# Staff Summary Report

**SUBJECT:** Hold a public meeting for a Development Plan Review for CVS PHARMACY # 9205 located at 802 South Mill Avenue.

DPR12046 – Development Plan Review for a site and landscape plan modification including removal of condition # 5 and condition # 7 of DPR07072.

DRAWING BY: DOM  
 DATE: 01-MAY-2012  
 JOB NUMBER: 42477  
 TITLE: **SITE PLAN**

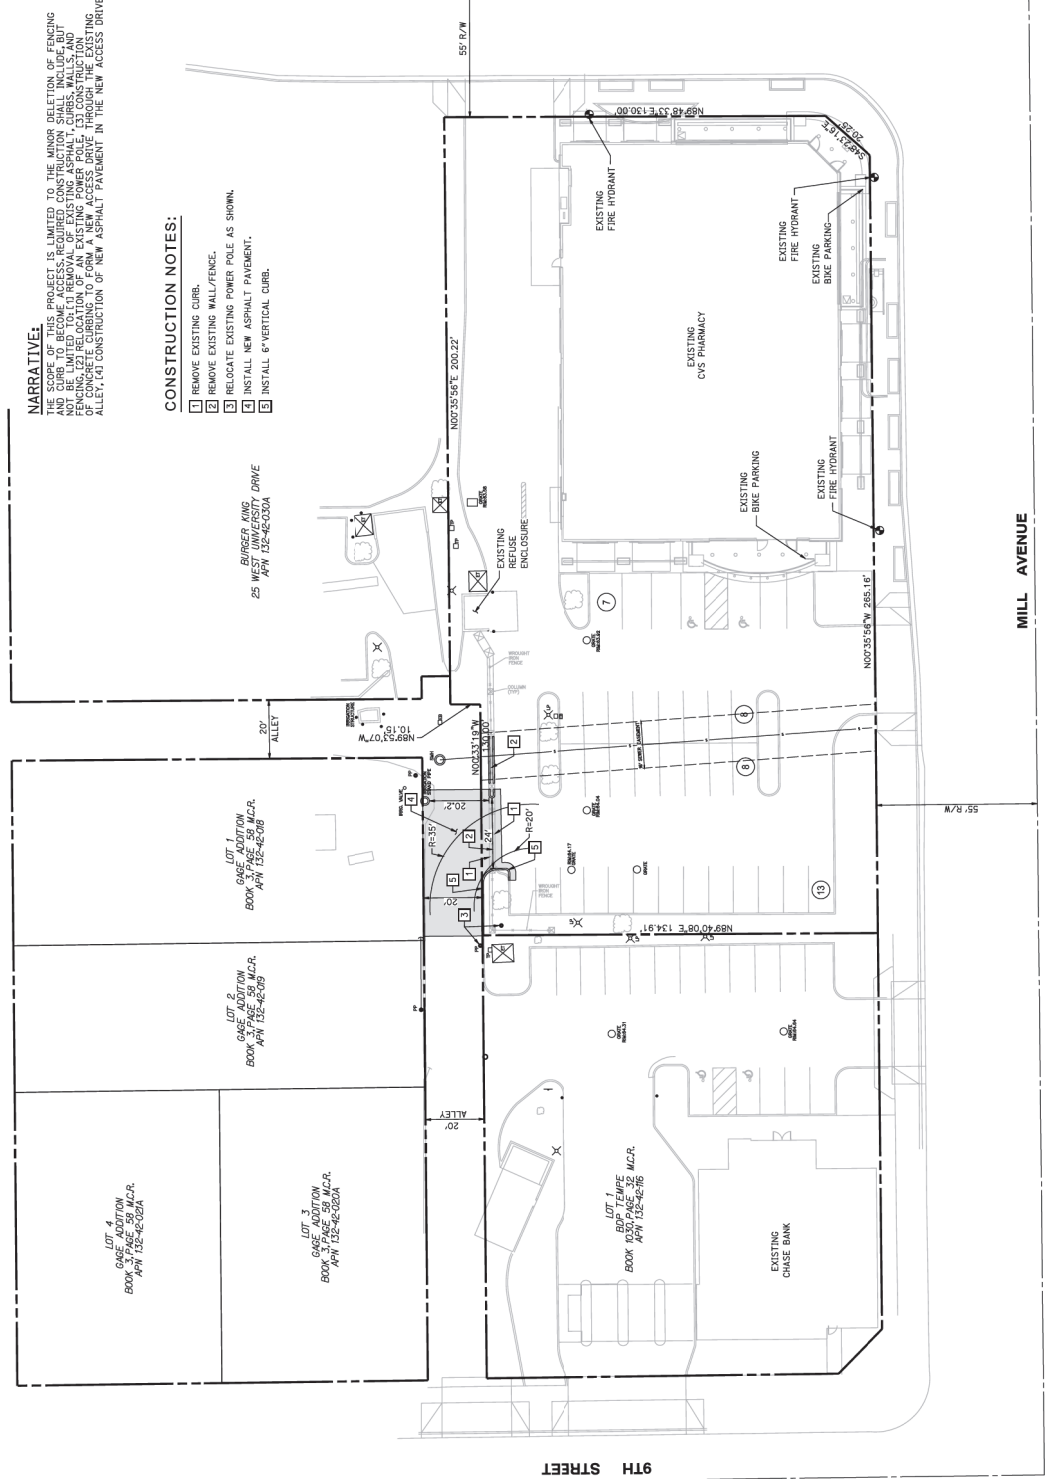
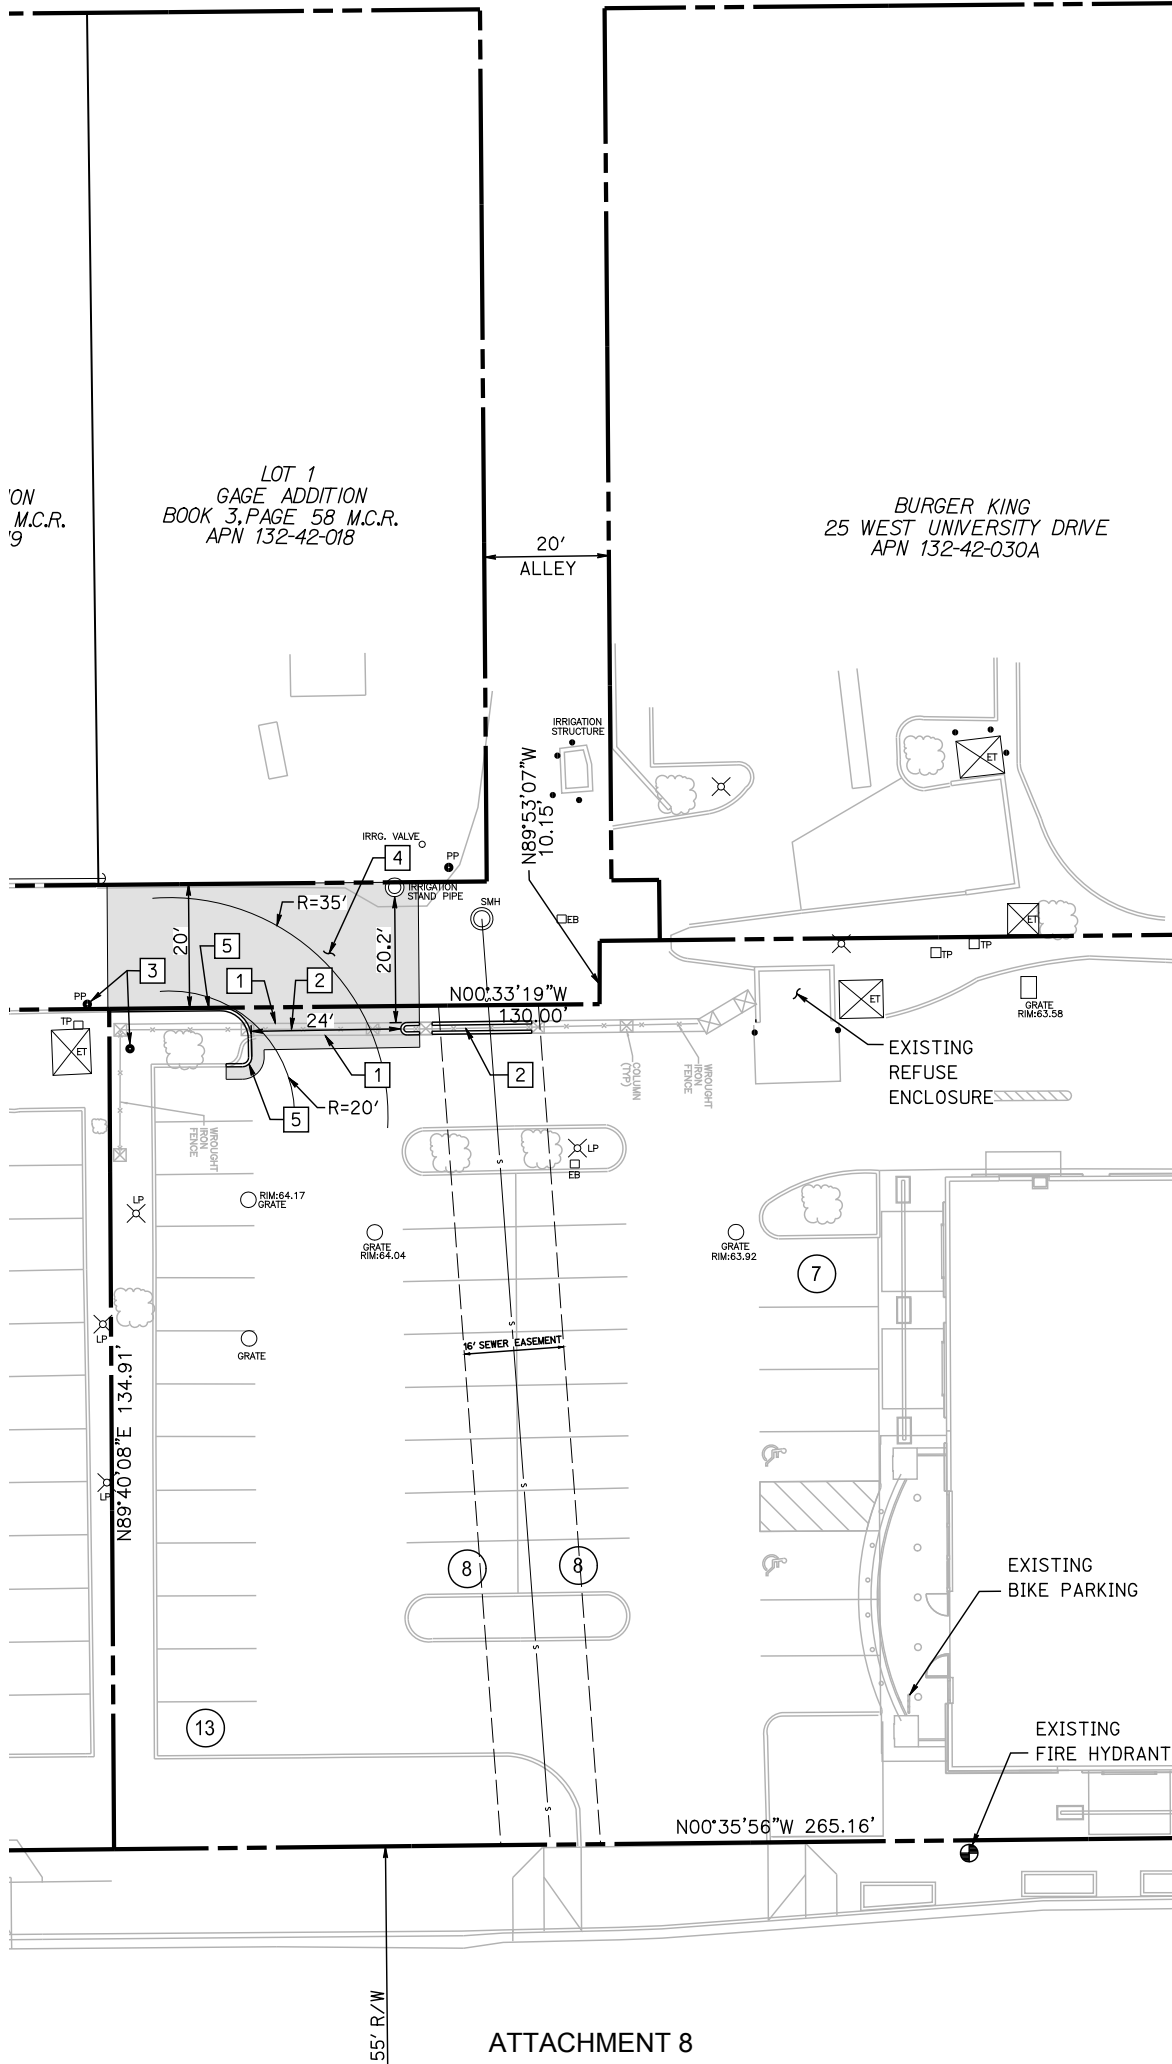
3. Modify view fence on west property line of CVS as follows. Indicate locations of existing fence pilasters. South of the public utility service gate and gate pilaster, remove the following items and create an opening approximately 26'-0" wide. 1) Remove the short fence section. 2) Remove the fence section south of this section that aligns with the CVS south drive aisle. 3) Remove the pilaster in between these two fence sections. 4) Remove the curb at the two removed fence sections. Do not modify any other part of the existing view fence to the north or south of this opening. Retain view fence at the southwest corner of the site and the section that separates the CVS and Chase Bank sites. Retain the utility service gate and the fence sections north of the proposed driveway opening. Refinish existing pilasters at edges of driveway so fastener holes are satisfactorily patched after fence sections are removed. Coordinate curb removal at approximate 26'-0" wide driveway with Engineering Division requirements. Modify grading and drainage so site does not outflow into alley and alley outfall requirements are satisfied.

4. Repave 20'-0" wide public alley from the southwest corner of the CVS site to Burger King. Repave the 15'-0" wide east-west alley between the CVS site and Maple Avenue. Provide asphaltic concrete paving subject to Engineering Division design standard except provide minimum 8" wide flush concrete curb at each line of flexible tubular markers. Design flush curbs so they may receive the fasteners of the markers. See the following condition for flexible tubular markers.

5. Install 3'-0" high, tee profile, flexible tubular markers at either end of the 15'-0" wide east-west alley. Place the west row of four markers in the alley in line with the Maple Avenue screen wall of Burger King. Place the east row of four markers immediately east of the eastern wall of the rectangular irrigation structure in the alley. Position markers at 4'-0" on center across width of alley. Center the line of markers in the width of the public right of way. Provide white markers with red reflective tape. Review existing installations of flexible tubular markers at the Sixth Street turnaround south of City Hall and at the northeast corner of University Drive and Lindon Lane.

6. Extend the alley curb at the northwest corner of the Chase Bank site onto the CVS site and return the curb at the south pilaster of the proposed vehicle entrance. Locate the alley light pole between this curb and the CVS fence. See the following condition for the alley light relocation. Repave the alley section at the removed light pole.
